Pine Valley Forevergreen - 95 - 1 - 42.02 A ROSEDALE
CENTRAL VAC AND WIRING

The Rosedale

JUNE 7 2019.

GROUND FLOOR | ELEV. A

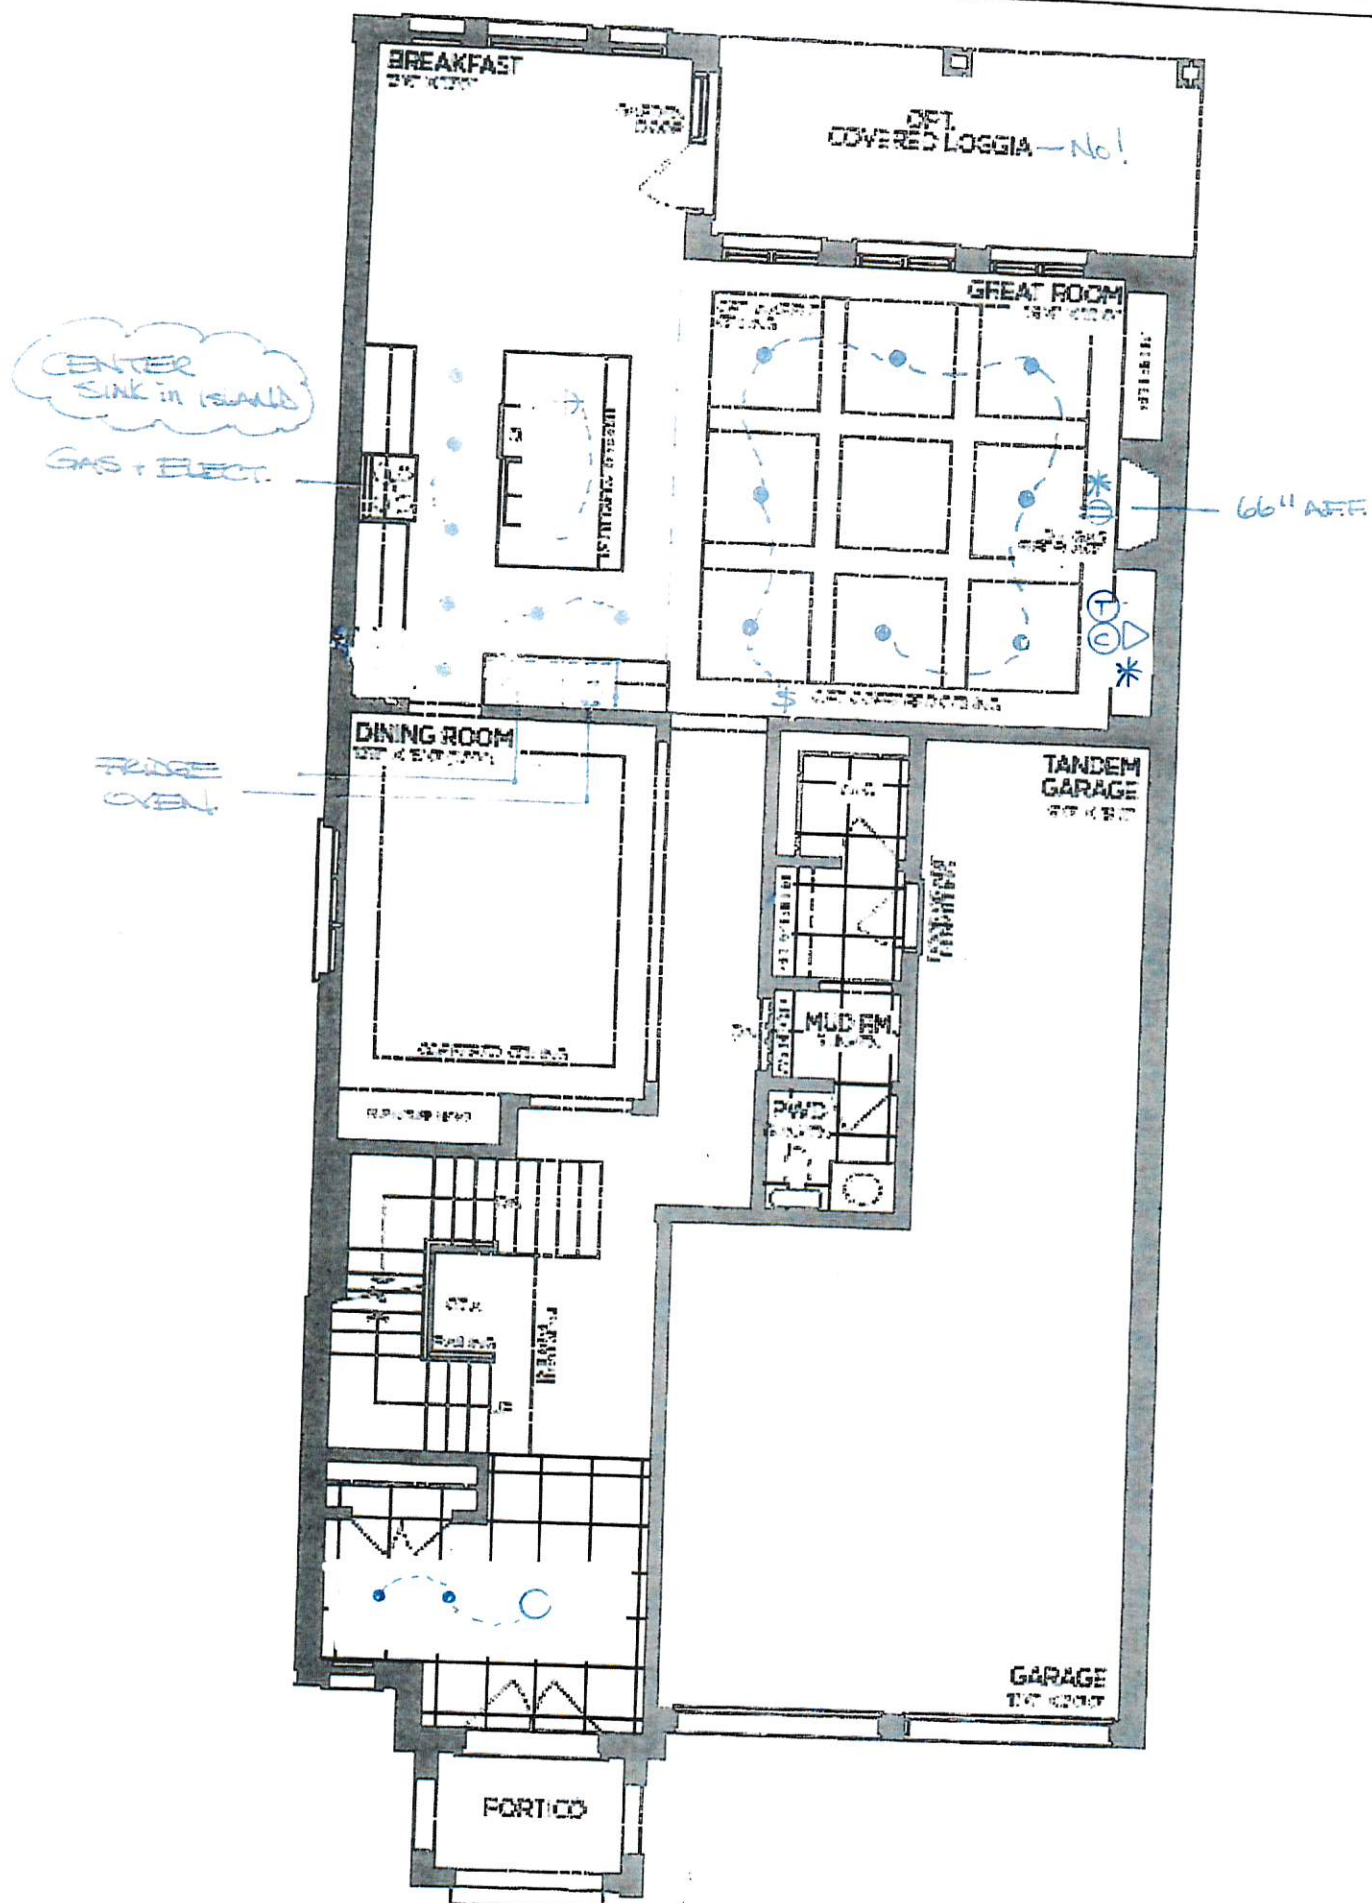
Inv.1,996	1 - GREAT ROOM: TERMINATE CONDUIT FROM ABOVE THE FIREPLACE IN GREAT ROOM - LOCATE APPROX. 66" A.F.F. TERMINATING BY CABLE OUTLET, SEE PLAN FOR LOCATION
Line28309	Note:
7Jun19 / 16Jul19	
Inv.1,996	1 - CONDUIT PIPE TO BE RUN IN A STRAIGHT LINE FROM ATTIC TO ELECTRICAL PANEL
Line28380	Note: AS CLOSE TO CENTER OF ATTIC AS POSSIBLE
7Jun19 / 16Jul19

Inv.1,996	1 - GREAT ROOM: UPGRADE TO COFERRED CEILING - GREAT ROOM
Line28311	Note:
7Jun19 / 16Jul19	
Inv.1,996	1 - GREAT ROOM: UPGRADE TO WAFFLE CEILING - 9-BOX
Line28312	Note: CTR-BO7 PROFILE
7Jun19 / 16Jul19

Inv.1,996	1 - GREAT ROOM: ADD A 110V RECEPTICLE ON A SEPARATE CIRCUIT - FOR FUTURE T.V. - TELEVISION NOT INCLUDED - LOCATE APPROX. 66" A.F.F. ABOVE FIREPLACE
Line28310	Note:
7Jun19 / 16Jul19	
Inv.1,996	8 - GREAT ROOM: ADD INTERIOR POT LIGHT - GROUND FLOOR
Line28313	Note:
7Jun19 / 16Jul19	
Inv.1,996	1 - GREAT ROOM: ADD A SEPARATE SWITCH - FOR LIGHTING PURPOSES
Line28314	Note: FOR POTLIGHTS
7Jun19 / 16Jul19	
Inv.1,996	1 - KITCHEN: RELOCATE FRIDGE - SEE PLAN FOR LOCATION
Line28315	Note:
7Jun19 / 16Jul19	
Inv.1,996	1 - KITCHEN: ADD A 240V RECEPTICE ON A SEPARATE SWITCH - FOR FUTURE 'COMBO' WALL OVEN/MICROWAVE - WALL OVEN NOT INCLUDED - DOES NOT INCLUDE BREAKER THAT IS TO BE INSTALLED BY LICENSED ELECTRICIAN AND ARRANGED BY HOMEOWNER AFTER CLOSING
Line28316	Note:
7Jun19 / 16Jul19	
Inv.1,996	7 - KITCHEN: ADD INTERIOR POT LIGHT - GROUND FLOOR
Line28317	Note:
7Jun19 / 16Jul19	
Inv.1,996	1 - KITCHEN: ADD A SEPARATE SWITCH - FOR LIGHTING PURPOSES

Line28318	Note: FOR POTLIGHTS
7Jun19 / 16Jul19

Inv.1,996	1 - KITCHEN: RELOCATE ONLY - STANDARD CEILING LIGHT
Line28319	Note: RELOCATE TO ABOVE ISLAND, SEE PLAN FOR LOCATION
7Jun19 / 16Jul19	
Inv.1,996	1 - KITCHEN: ADD CAPPED CEILING ROUGH-IN FOR FUTURE INTERIOR LIGHT FIXTURE - FIXTURE NOT INCLUDED
Line28320	Note: LOCATE ABOVE ISLAND, USE SAME SWITCH AS STANDARD CEILING LIGHT - SEE PLAN FOR LOCATION
7Jun19 / 16Jul19	
Inv.1,996	1 - KITCHEN: ADD FULL ELECTRICAL VALANCE LIGHTING UNDER UPPER CABINETS IN KITCHEN ON A SEPARATE SWITCH - REQUIRES PURCHASE OF VALANCE CABINETRY
Line28322	Note:
7Jun19 / 16Jul19	
Inv.1,996	1 - MASTER ENSUITE: ADD CAPPED CEILING ROUGH-IN FOR FUTURE INTERIOR LIGHT FIXTURE - FIXTURE NOT INCLUDED
Line28331	Note: LOCATE ABOVE TUB
7Jun19 / 16Jul19	
Inv.1,996	1 - MASTER ENSUITE: ADD A SEPARATE SWITCH - FOR LIGHTING PURPOSES
Line28332	Note: FOR LIGHT ABOVE TUB
7Jun19 / 16Jul19	
Inv.1,996	4 - MASTER BEDROOM: ADD INTERIOR POT LIGHT - SECOND FLOOR

Inv.1,996	1 - KITCHEN: ADD GASLINE FOR FUTURE COOKTOP - COOKTOP NOT INCLUDED - NEW 110V RECEPTICLE REQUIRED & INCLUDED WITH THIS PURCHASE
Line28326	Note:
7Jun19 / 16Jul19

Inv.1,996	1 - KITCHEN: CENTER SINK IN ISLAND
Line28321	Note:
7Jun19 / 16Jul19

Inv.1,996	1 - KITCHEN: ADD WATERLINE FOR FRIDGE
Line28327	Note:
7Jun19 / 16Jul19

SECOND FLOOR | ELEV. A

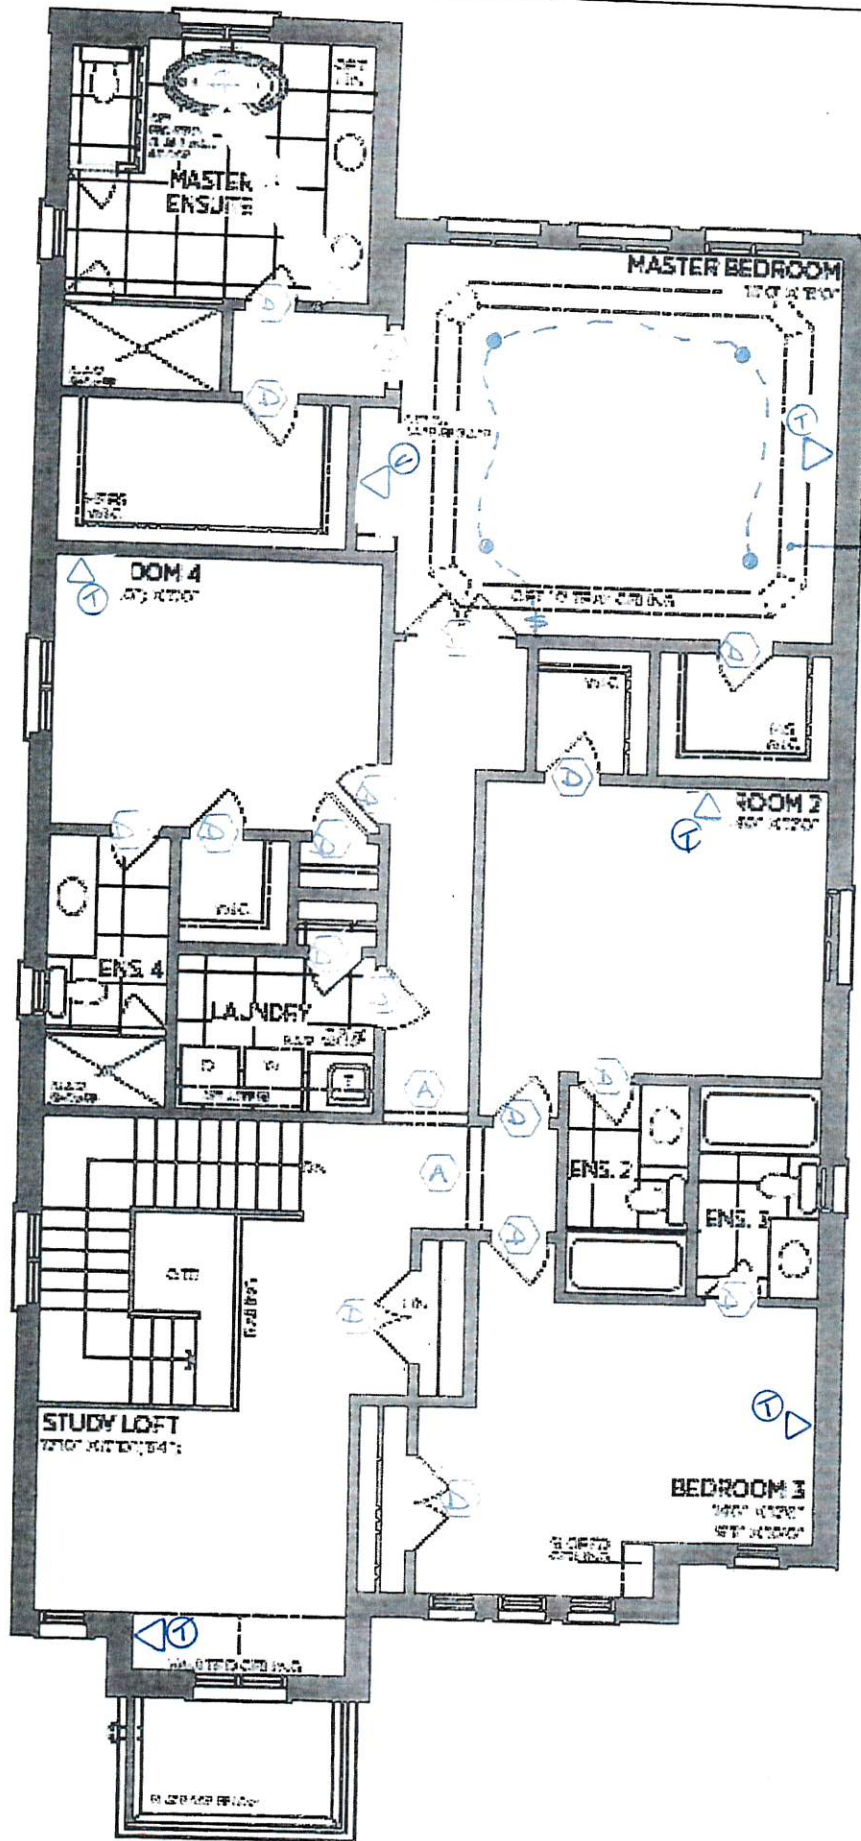
Inv.1,996	1 - 2ND FLOOR: UPGRADE TO SMOOTH CEILINGS - THROUGHOUT SECOND FLOOR
Line28323	Note:
7Jun19 / 16Jul19

Line28333	Note:
7Jun19 / 16Jul19	
Inv.1,996	1 - MASTER BEDROOM: ADD A SEPARATE SWITCH - FOR LIGHTING PURPOSES
Line28334	Note: FOR POTLIGHTS
7Jun19 / 16Jul19	
Inv.2,004	2 - FRONT ELEVATION: ADD EXTERIOR POT LIGHTS
Line28483	Note:
13Jun19 / 16Jul19	
Inv.2,004	1 - FOYER: ADD A SEPARATE SWITCH - FOR LIGHTING PURPOSES
Line28484	Note: FOR SOFFIT LIGHTS
13Jun19 / 16Jul19	
Inv.2,004	2 - FOYER: ADD INTERIOR POT LIGHT - GROUND FLOOR
Line28641	Note: USE SAME SWITCH AS STANDARD CEILING LIGHT, SEE PLAN FOR LOCATION
13Jun19 / 16Jul19

Inv.1,962	1 - ADD OPTIONAL TRAY CEILING IN MASTER BEDROOM
Line27509	Note:
9Jan19 / 10Jan19	
Inv.1,996	1 - note: COFFERED CEILING IN GREAT ROOM
Line28378	Note:
7Jun19 / 16Jul19

Inv.1,996	1 - note: 96" DOORS AND ARCHES ON 2ND FLOOR
Line28379	Note:
7Jun19 / 16Jul19

Inv.1,996	1 - MASTER ENSUITE: UPGRADE FROM FRAMED GLASS SHOWER TO FRAMELESS
Line28324	Note:
7Jun19 / 16Jul19

Inv.1,996	1 - ENSUITE 4: UPGRADE FROM FRAMED GLASS SHOWER TO FRAMELESS
Line28325	Note:
7Jun19 / 16Jul19

Inv.1,996	20 - 2nd FLOOR: UPGRADE TO 96" DOORS
Line28329	Note:
7Jun19 / 16Jul19

Inv.1,996	3 - 2ND FLOOR: UPGRADE TO 96" ARCH
Line28330	Note:
7Jun19 / 16Jul19

Inv.1,996	1 - MASTER ENSUITE UPGRADE STANDARD SHOWER FIXTURE TO RAINSHOWER ARM (from ceiling) COMPLETE WITH HANDHELD Moen 90* -3 Function Shower System - 8" Rain Shower from ceiling + Handheld on Slide Bar #3570/PS3711/PS4172/3375/S3879EP/S6345/A725/116651
Line28328	Note:
7Jun19 / 16Jul19

BASEMENT | ELEV. A

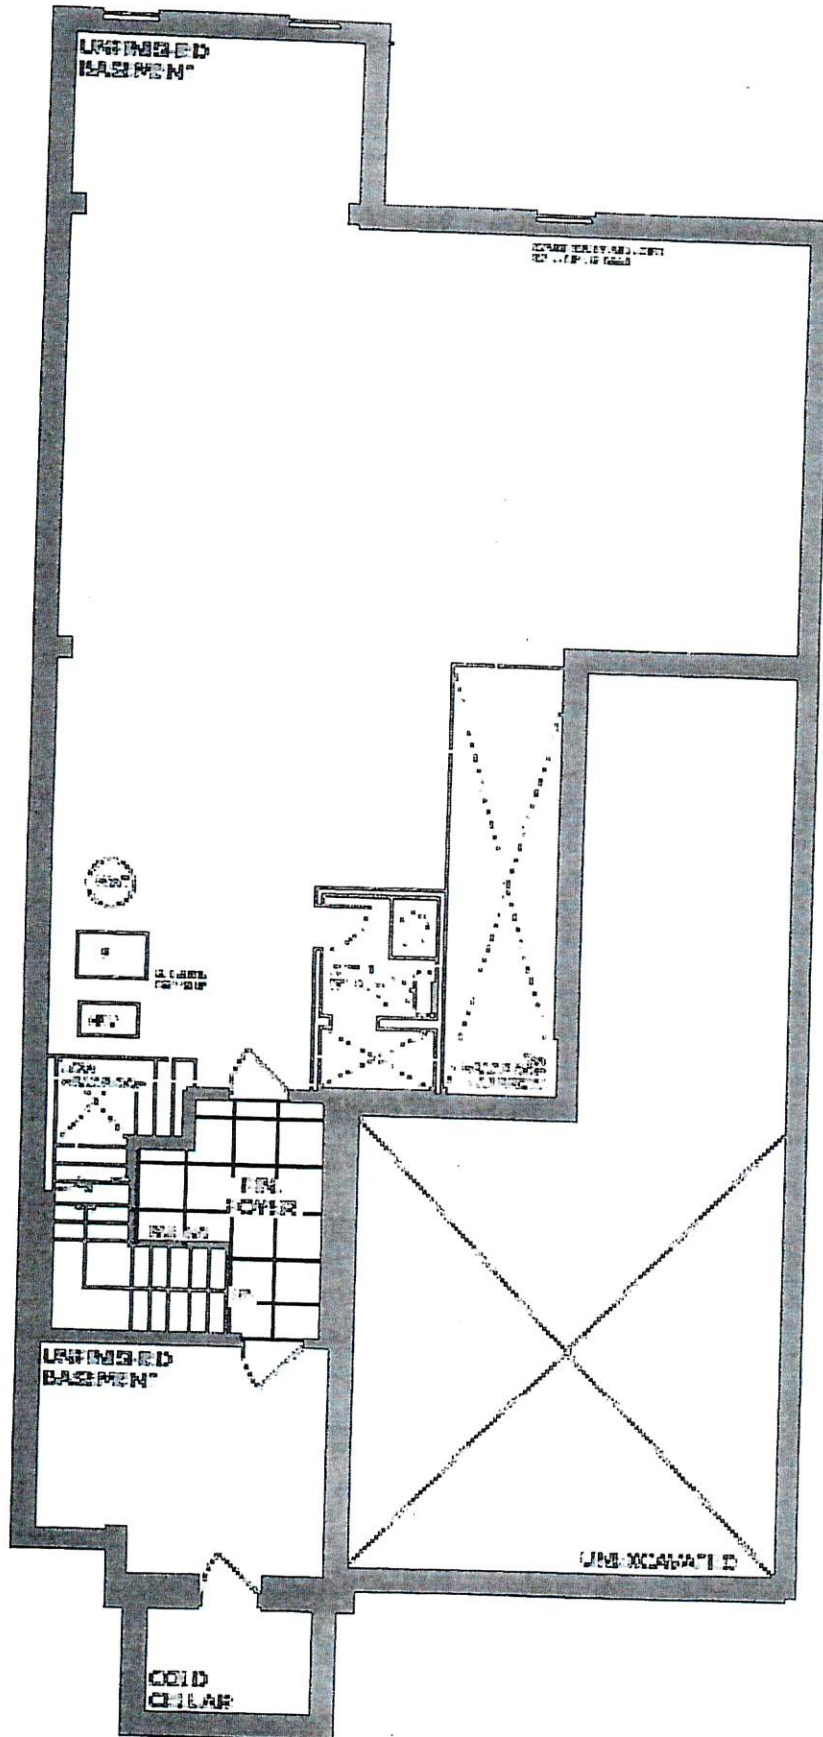
Inv.1,962	2 - ADD NEW BASEMENT WINDOW 30X16 INCHES
Line27508	Note: Please refer to floor plan drawing for locations, placing both windows directly across from one another.
9Jan19 / 10Jan19
